STRESS ANALYSIS

Subject: 18" Type 9200 containment isolation valves
Fisher Serial Numbers 127571-6 and 127579

RESPONSE TO NRC QUESTIONS

Subject: Northern States Power Order: MQ-05913
Fisher Controls Order: 099X-DIR-44455
Engineering Response/NRC Questions
18" Type 9200/656-60 Valve Assemblies
Serial No: 127571-76, 127579

Attachment 4: Torque-Pressure Drop
Relationships Used in
Butterfly Valve Dynamic
Torque Coefficient Selection

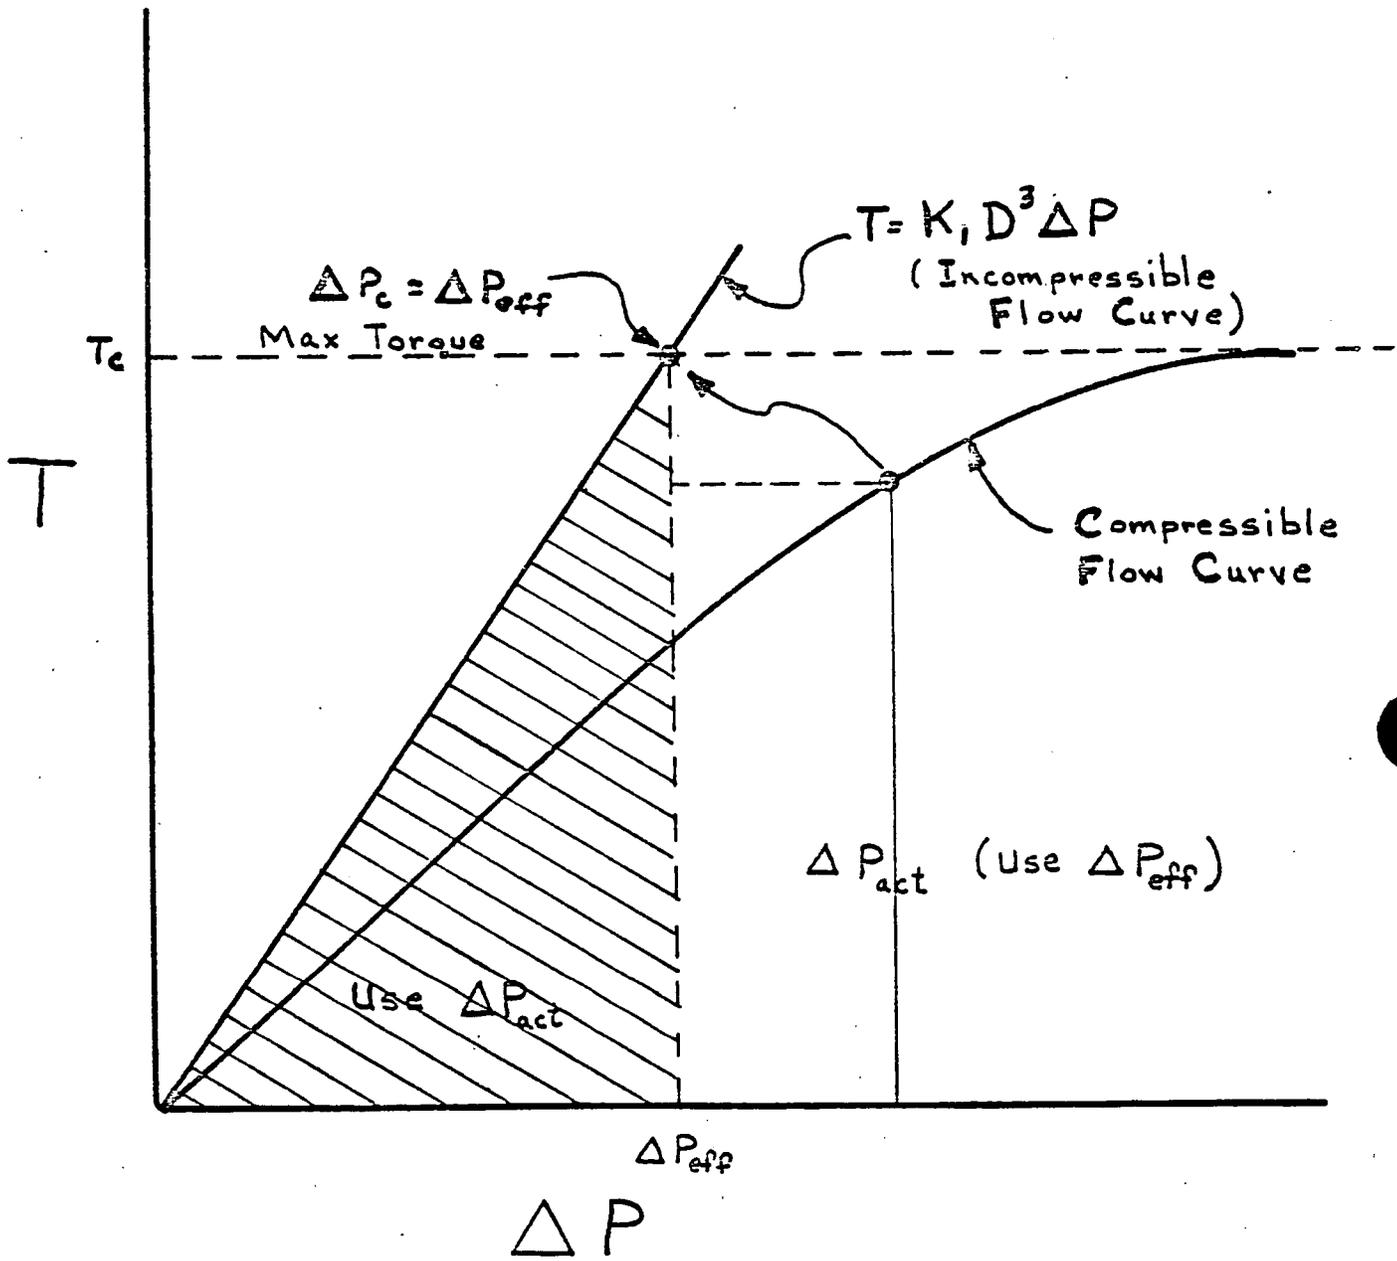
Question 2:

Application of the conclusions from the ISA paper are presented in Attachment 4: "Torque-Pressure Drop Relationships Used in Dynamic Torque Coefficient Selection", which is a representation of the Figure 5 curves from the ISA paper. This shows how the torque values for compressible flow are conservatively determined and related to incompressible flow torques. It should be noted that the compressible flow curve reaches a choked flow condition at larger ΔP values (for critical flow), resulting in a maximum torque value (T_c), which cannot be exceeded, regardless of how large ΔP becomes.

FIGURE A

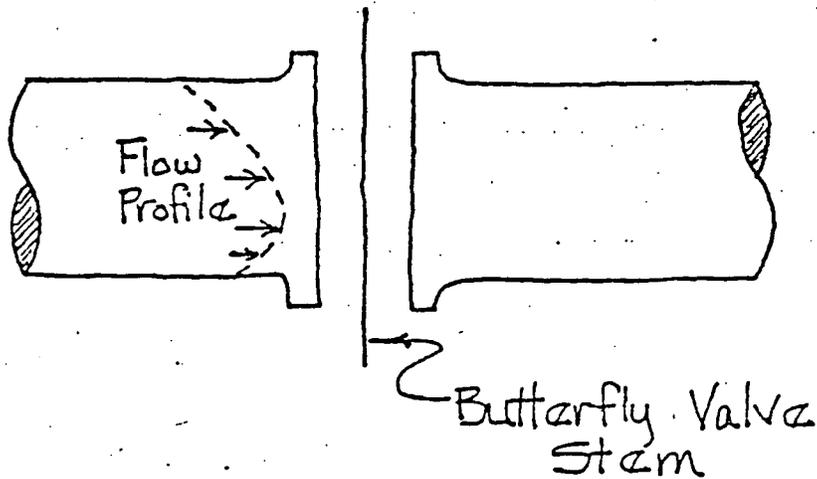
a. Valve/Flow Orientation, Figure A

If it has been determined that plant layout is such that the valve is oriented to the flow as depicted in Fig. A (Attachment 6), the non-uniform fluid profile is not expected to produce an additional torque on the valve disc since both "wings" of the disc (as split by the shaft) will be subjected to the same flow with respect to time.

FIGURE B

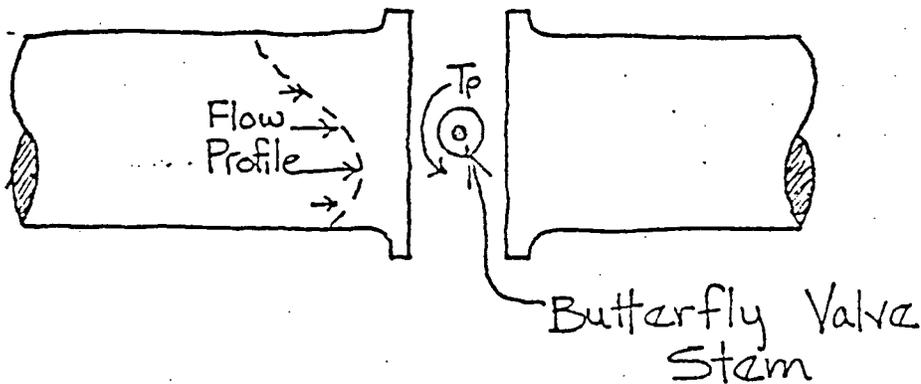
b. Valve/Flow Orientation, Figure B

If it has been determined that plant layout is such that the valve is oriented to the flow as depicted in Fig. B (Attachment 6), the non-uniform flow will affect the performance of the valve. The flow profile shown will probably produce some amount of torque, T_p , in the direction shown in Fig. B; obviously, if the torque rotational direction is coincident with valve closure,

NOTE: The above explanation must be coupled with exact installation details by the utility to determine how the closure function of a particular valve will be affected.

Attachment 7: Drawing H-14266. Type
656 Fisher Diaphragm Operator
w/164-A Seal System Assembly

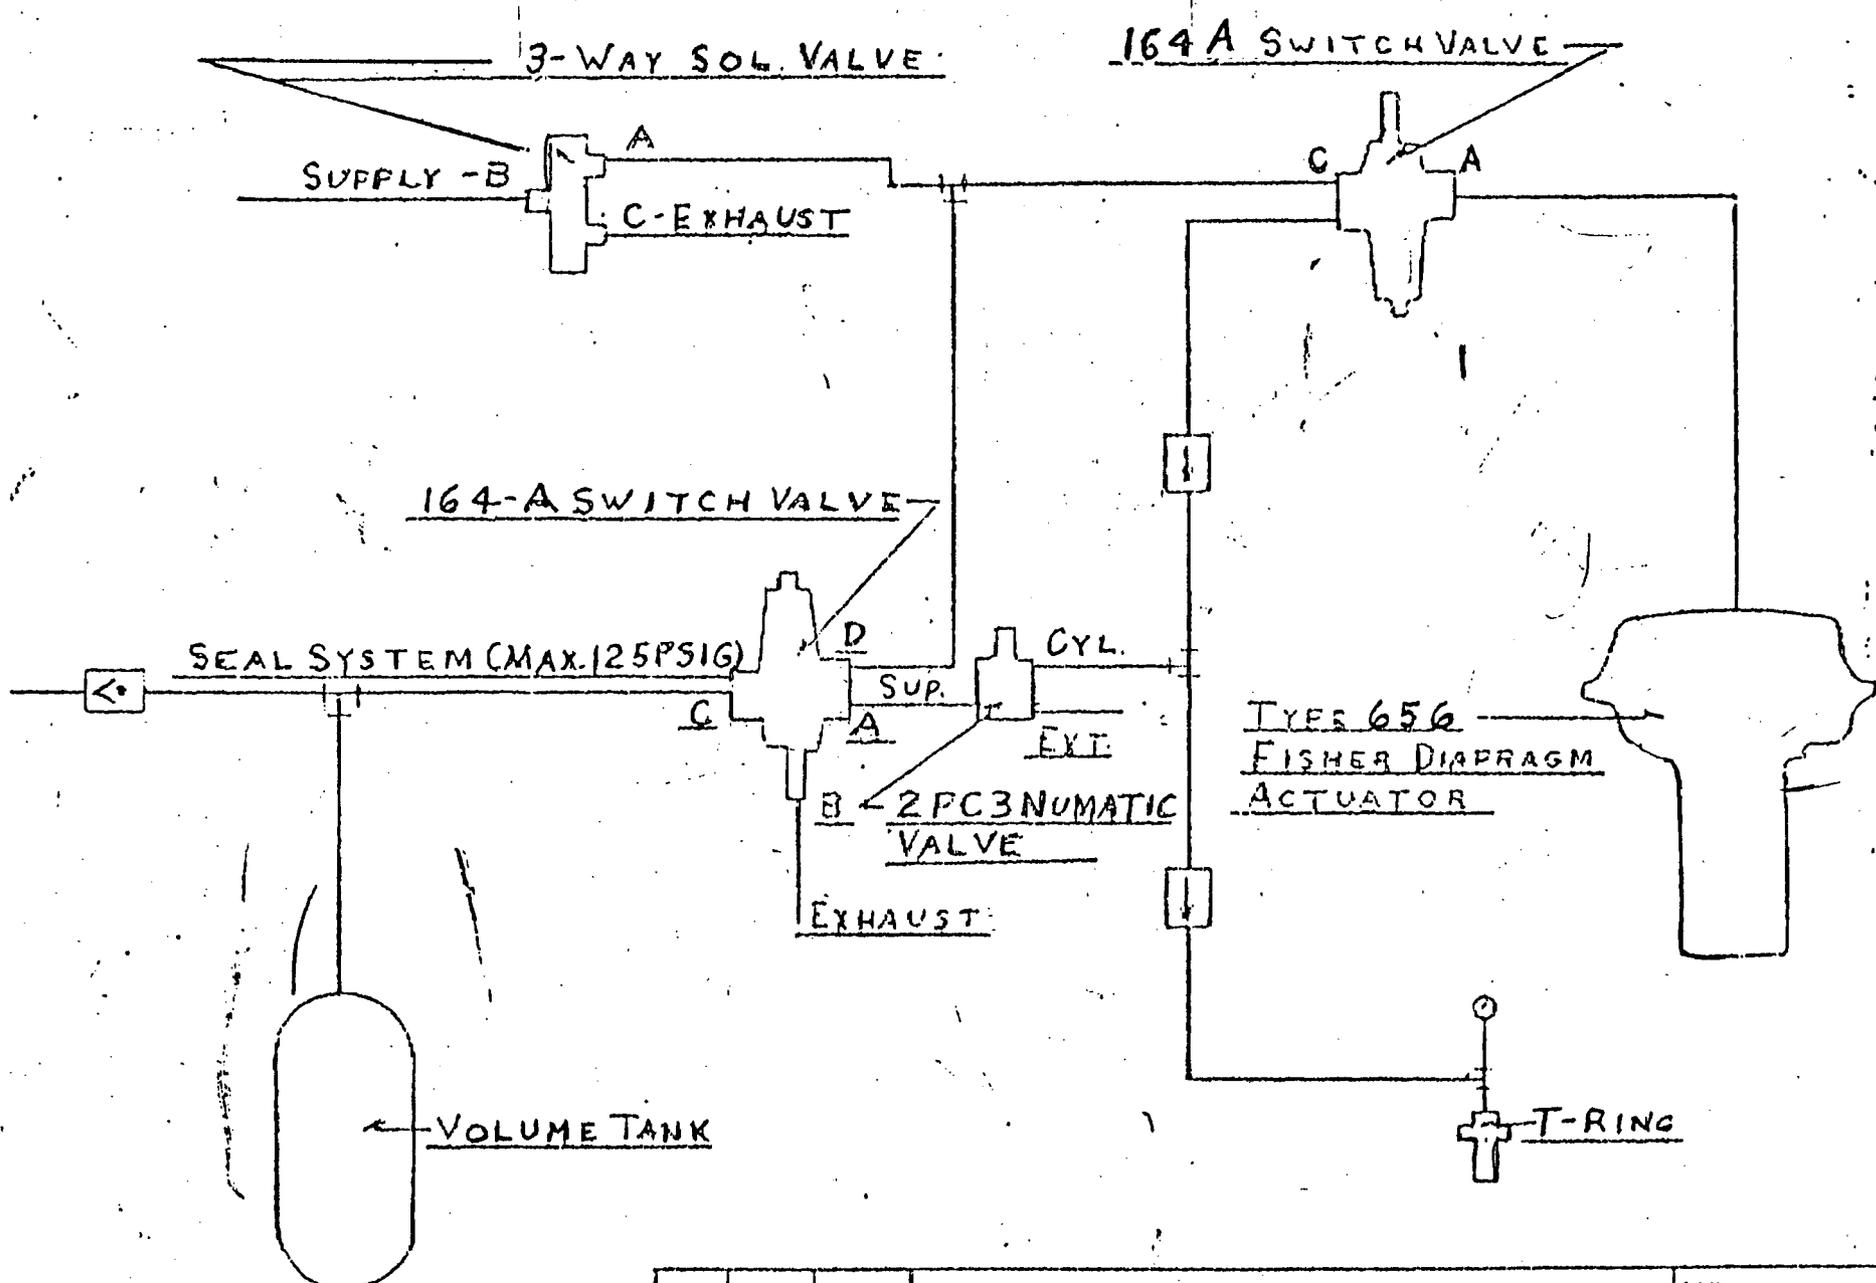
"For those valve assemblies (with air operators) inside containment, has the containment pressure rise (backpressure) been considered as to its effect on torque margins available (to close and seat the valve) from the actuator? During the closure period, air must be vented from the actuator's opening side through the solenoid valve into this backpressure. Discuss the installed actuator bleed configuration and provide the basis for not considering this backpressure effect a problem on torque margin. Valve assemblies using 4-way solenoid valves should especially be reviewed."

- a. The control piping schematic for the subject valves is included as Attachment 7 (Drawing H-14266). This piping system is rather complex, since the valves are equipped with Type 656-60 spring-return actuators and with an associated seal pressurization system. The spring side of the diaphragm actuator is vented to the local ambient conditions; if the pressure side is vented (through the solenoid or 164A) to the same local ambient conditions, no pressure differential will exist across the diaphragm as a result of a surrounding local pressure rise. The spring will still drive the actuator to the safety-mode (closed) position and maintain that position as long as the solenoid remains de-energized and as long as no subsequent re-opening signal is received.

- c. Adequate spring-driven torque output is available from the actuator to close the valve from any open position up to 40° open (regardless of external ambient pressure), providing the spring side of the diaphragm casing is vented (locally). The torques discussed in response to Question 5 above are the opening torques, since dynamic flow effects tend to close the valve or have a neutral effect in the opening range of interest (0°-40°). (See typical curve in Attachment 5.) In any event, the torque values are well within the capabilities of the 656-60 actuator, provided the valve is pinned at a maximum angle of 40° open. (Note: The spring driven torque capabilities given below are based on an initial actuator bench set of 6 psig for initial compression of Spring 1K1628 when the valve is in the closed position.)
